CITY OF ALBUQUERQUE

**RE: Springstone Parking Lot and Garage
9010 Davenport St NW
Grading and Drainage Plan Stamp Date: 10/10/19
Hydrology File: C12D003B2**

SUBJECT: *Springstone Parking Lot and Garage*
9010 Davenport Street NW
Grading & Drainage Plan (C12/D003B2)

DRAWN BY: DAL

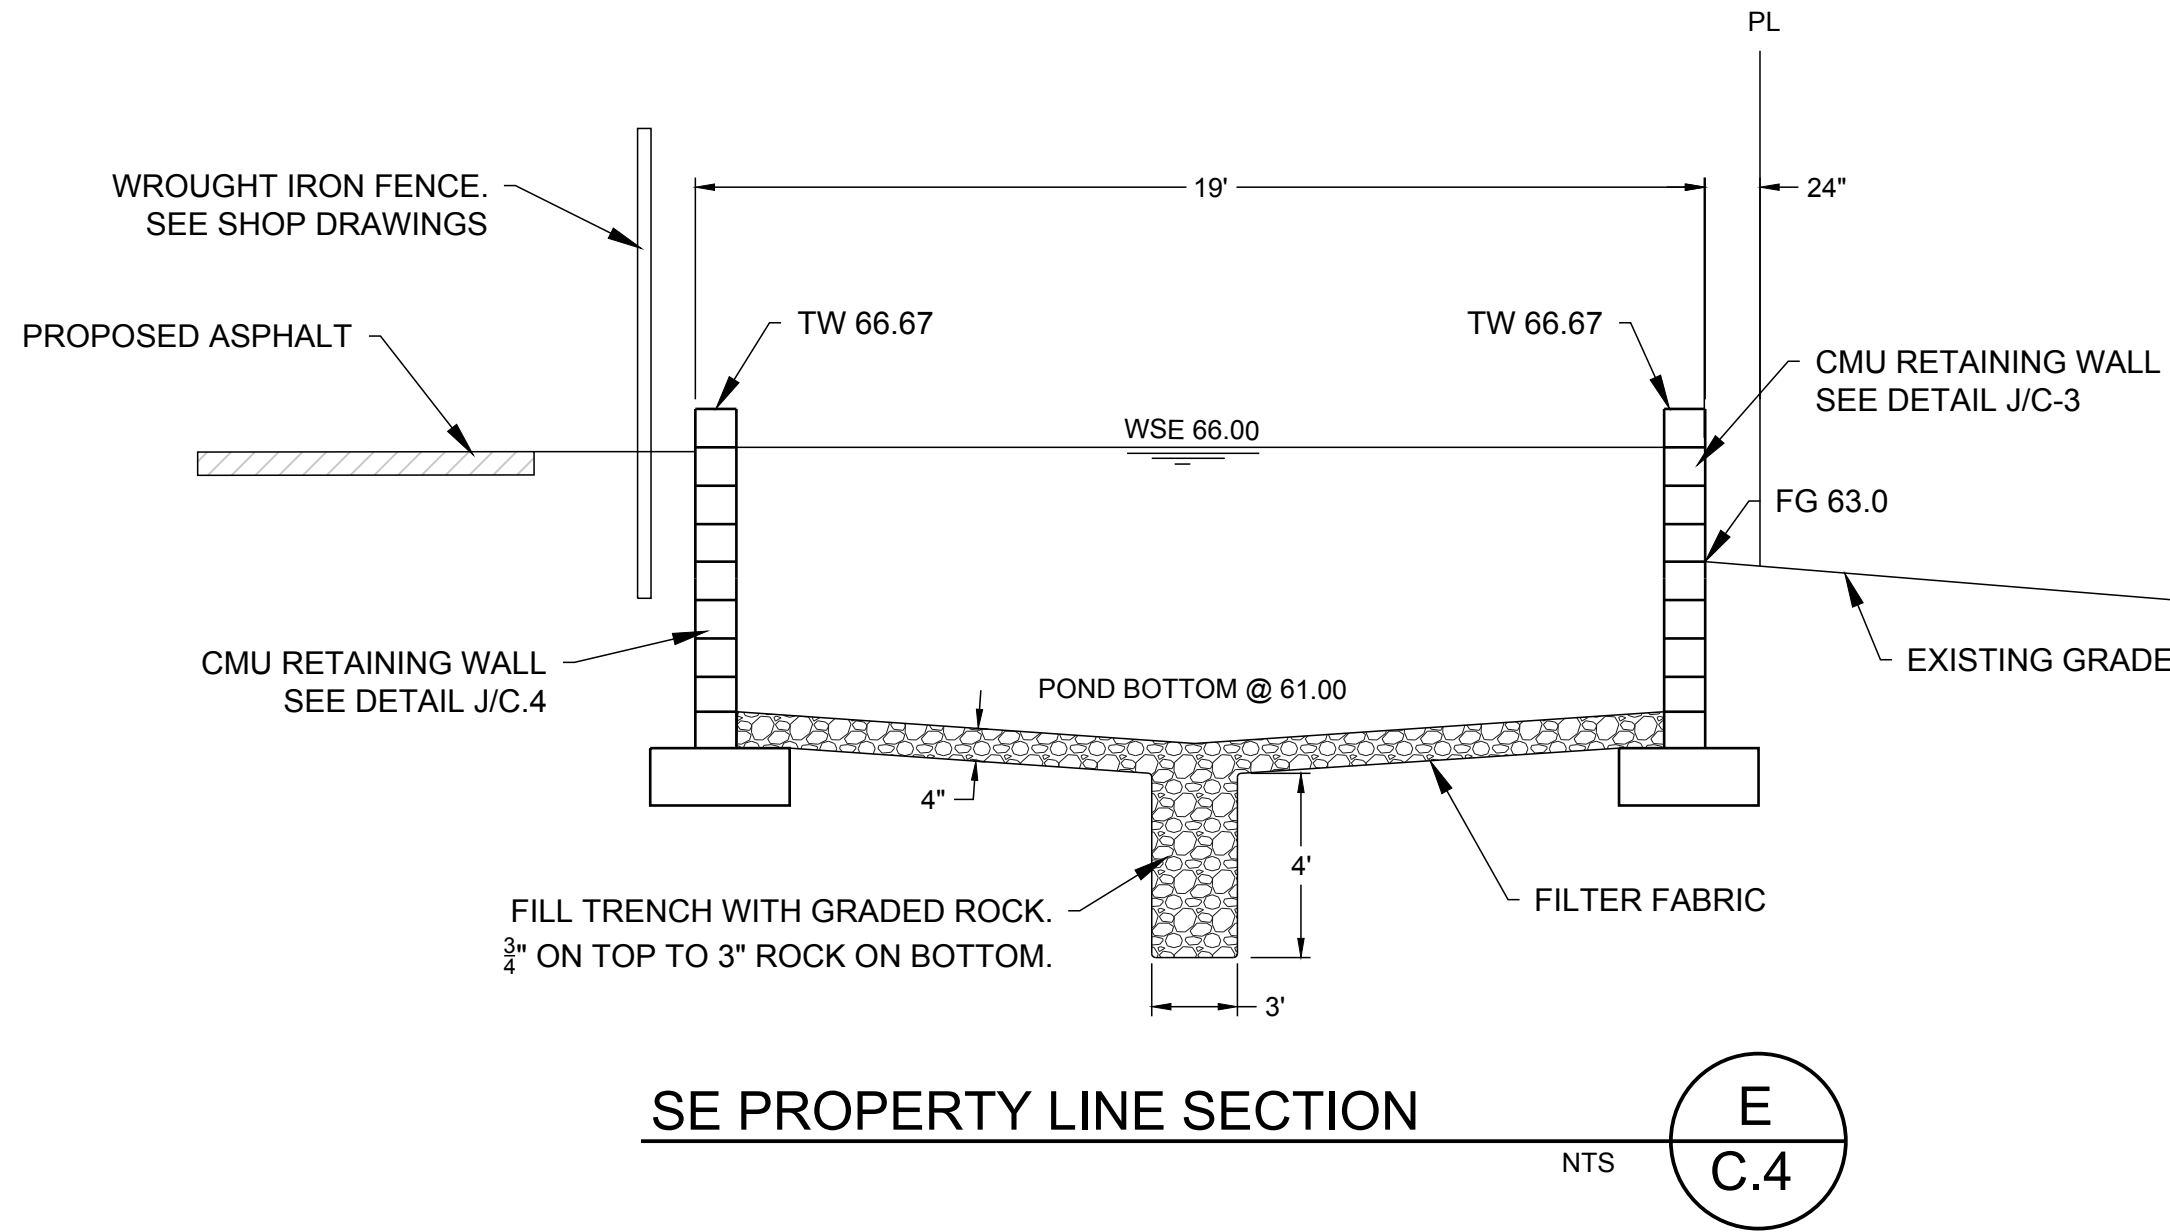
1. To avoid excessive fill and retaining walls the site will implement a 100-year-10-day retention pond.
2. The property address is provided on the Plan.
3. Property line sections are provided on Detail Sheet C.4.
4. The short version of AHYMO for small watersheds was used to calculate developed flowrates and volumes.
5. The project benchmark is provided on the Plan.
6. Attached is an unsigned copy Drainage Covenant. I will submit a signed original to Madeline Carruthers after the G&D Plan is approved.
